DISPLAY/OPTIC PRODUCT MODIFICATION

HMI[®] 18000W/SE GX51

July 2010

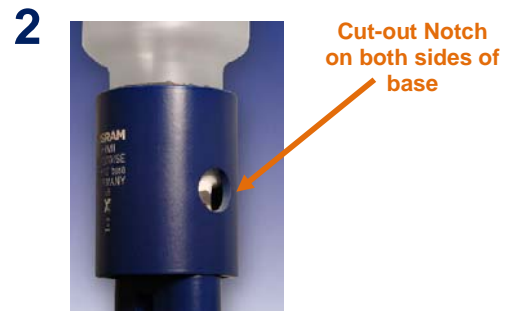
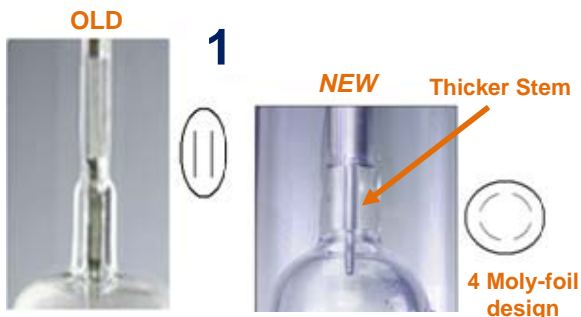
Old version:
Product No. 54289

New version:
Product No. 54324

- 1) **Thicker stems provide a more robust lamp design, resulting in less breakage during transport. The dual Moly-foil shaft has been upgraded to a highly successful, four Moly-foil design which distributes the heat more evenly. The four Moly-foil design incorporated in the new HMI 18000W/DXS and HMI 24000W/DXS lamps has created an increase of life by > 25%.**
- 2) **New base design with cut-out notches to allow greater airflow and resistance to heat in the fixture.**
- 3) **Additional outer shipping box with trampoline support to reduce shock and impact during shipping and transportation.**

- Geometrical data and fit of the base remain unchanged.
- Technical data and lamp performance/output are similar. Product number 54324 is entirely compatible and a direct replacement to product number 54289.
